IEEE P802.11

Fixed Fragment Size per MSDU

Michael Fischer
Digital Ocean, Inc.
4242-3 Medical Drive
San Antonio, TX 78229

This submission contains modified text for a portion of section 6.4 of the D2.0 draft to remove the possibility of variation of fragment sizes for hop dwell optimization. Voters favoring this proposal can cite this document as the source of replacement text for their D2.0 letter ballot comments.

Figure 6-21: Fragmentation Near a Dwell Boundary

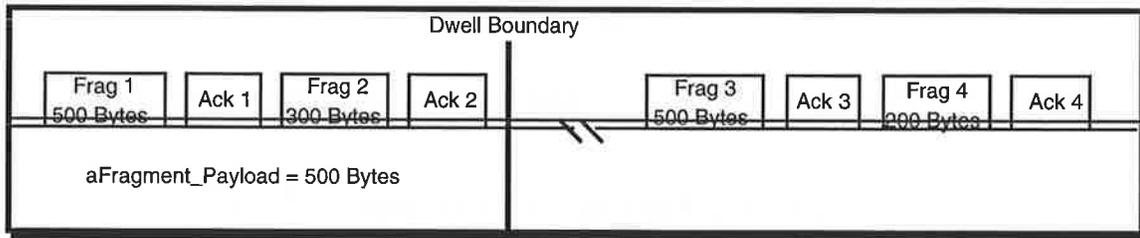
~~Since the control of the channel will be lost at a dwell time boundary and the station will have to contend for the channel after the dwell boundary, it is required that the acknowledgment of a fragment be transmitted before the stations cross the dwell time boundary. Hence, if there is not enough time remaining in the dwell time to transmit a fragment with an aFragment_Payload payload, the number of octets in the payload may be reduced to the maximum number of octets that will allow the fragment plus the MAC acknowledgment to fit within the time remaining in the dwell time. This is shown in Figure 6-21 for an MSDU of 1500 octets.~~

Referring to Figure 6-21, a 1500 octet MSDU is fragmented into four fragments with aFragment_Payload set at 500 octets. There is enough time left in the dwell to send two fragments, one of 500 octets and a second of 300 octets. After the dwell boundary, the rest of the MSDU is sent, one 500 octet fragment and one 200 octet fragment.

~~When an MSDU data is to be transmitted, the number of octets in the payload of each the fragment, other than the final fragment, shall be set to an equal value less than or equal to aFragment_Payload. The number of octets in the payload of the final fragment of an MSDU shall not be greater than the number of octets in the preceding fragments of the MSDU. be determined based on the time at which the fragment is to be transmitted for the first time. Once any fragments of an MSDU have been a fragment is transmitted for the first time, the fragment sizes its contents shall be fixed for the remainder of the MSDU lifetime, including any retransmissions that may be necessary until it is successfully delivered to the immediate receiving station.~~

Figure 6-22: Fragmented MSDU with missed ACK Near a Dwell Boundary

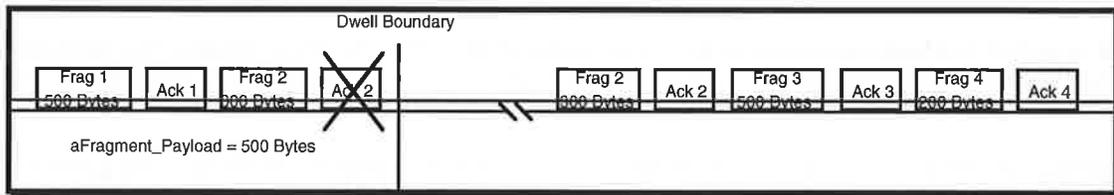
If a fragment requires retransmission, its contents and length shall remain fixed for the lifetime of the MSDU at that station. In other words, after a fragment is transmitted once, contents or length of that fragment are not allowed to fluctuate to accommodate the dwell time boundaries. Let the fragmentation set refer to the contents and length of each of the fragments that make up the MSDU. The fragmentation set is created at a station as soon as the fragments are attempted for the first time. The fragmentation set remains fixed for the lifetime of the packet at the transmitting station. This is shown in Figure 6-22.

In the example shown in Figure 6-22, the same 1500 octet MSDU is fragmented at the same point in the dwell time as in Figure 6-21 but the ACK for the second fragment is missed. After the dwell boundary, the fragment is retransmitted and the fragment size remains 300 octets.
